U. S. NUCLEAR REGULATORY COMMISSION

Report No.: 50-461/90005(DRS)

Facility Name: Clinton Power Station

Areas Inspected: Special, announced team inspection of a licensee identified reportable event of inadequate design flow through components using the Shutdown Service Water (SX) System for cooling water, and actions associated with Generic Letter (GL) 89-13, "Service Water System Problems Affecting Safety-Related Equipment".

FIGURE 1. Emergency Diesel - SX System Interface

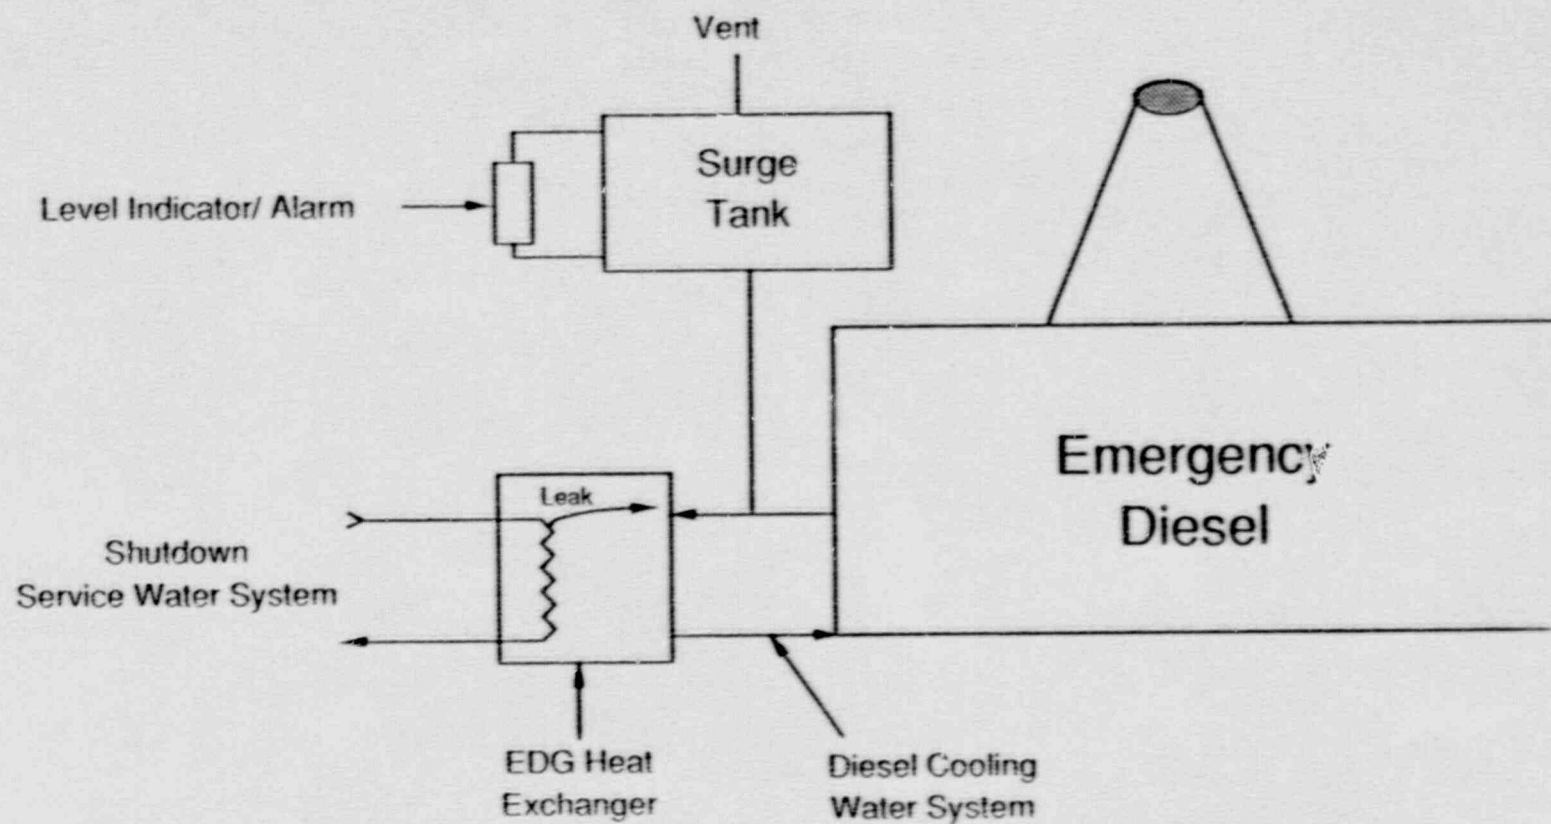
In late December 1989, after approximately three years of commercial operation, a Division I emergency diesel expansion tank high level was observed. The high level was caused by apparent in-leakage from the SX system (having a line pressure of approximately 100 psig) to the emergency diesel generator (EDG) engine closed cooling water system (slightly above atmospheric pressure), reference Enclosure 2. The Division I EDG was declared inoperable and, during the subsequent Limiting Condition for Operation (LCO) of 72 hours, the licensee examined the suspect HX and found through wall pitting in one tube of the dual HX units. The defective tube was replaced with a new tube of like material (90/10 Cu/Ni), the HX was tested, and the EDG was returned to service.

Approximately one week later, a similar tube failure occurred. The HX was repaired, eddy current tested and approximately half of the tubes were cleaned, within a 72 hour LCO. A third failure took place on January 15, 1990, at which time the licensee completely retubed and hydrostatically tested both Division I EDG HX units. A consultant associated with the Electric Power Research Institute (EPRI) was called in to examine the degraded HXs and identified the degradation mechanism as local Microbiologically Induced Corrosion (MIC) accelerated by the thermal and stagnation environment present in the EDG HX tubes.

Suspecting that a global MIC condition could exist in the SX System, the licensee commenced an inspection of all Division I HXs (see Enclosure 3) to assess their physical condition. The remaining Division I HXs exhibited only minor tube wall pitting (maximum depth of 20% wall), along with moderate general corrosion and light siltation. The lack of evidence of widespread MIC attack supports the theory that the combination of thermal and stagnation conditions found in the EDG HXs promoted micro-organism growth and the resulting degradation of the copper-nickel tube wall.

FIGURE 4. Component Differential Pressure Drops

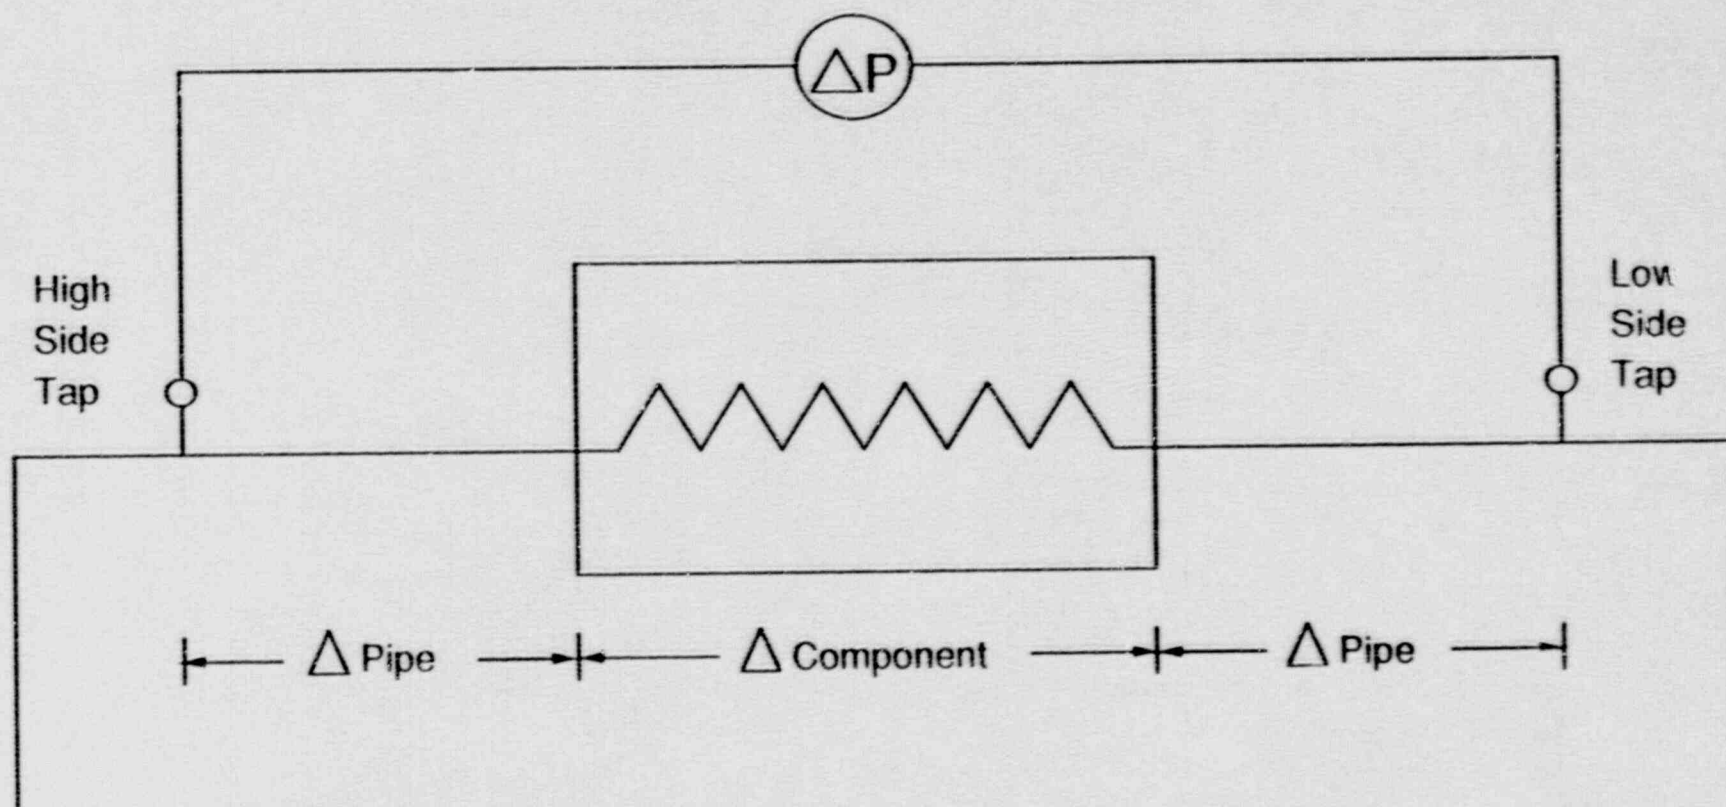
It was noted during the review that the acceptable flow rate values supplied by engineering made no additional allowances for any pressure drops between the taps for differential pressure measuring devices and the cooling coils. The vendor supplied pressure drop data was accountable only for the pressure drop across the coil. The actual locations of the instrumentation used during the preoperational tests could not be established, but assumptions were made of the possible pressure tap locations and additional line losses should have been accounted for. (Reference: Enclosure 4)

Until 1989, Clinton, like most utilities, primarily depended on differential pressure (DP) measurements to balance and ensure adequate mass flow to the multiple parallel heat exchangers in the SX System (see Enclosure 4). Vendor measurements of pressure drop as a function of mass flow through the individual HX tubing were used in conjunction with a temporarily installed differential pressure transducer to adjust a throttling valve located on the inlet side of most of the HX components. This approach to determining component mass flow presents several possible generic mechanism problems which were discussed in Paragraph 2.c. of this report. With the advent of high accuracy nonintrusive liquid velocity measurement devices, a check on the original methodology is now available.
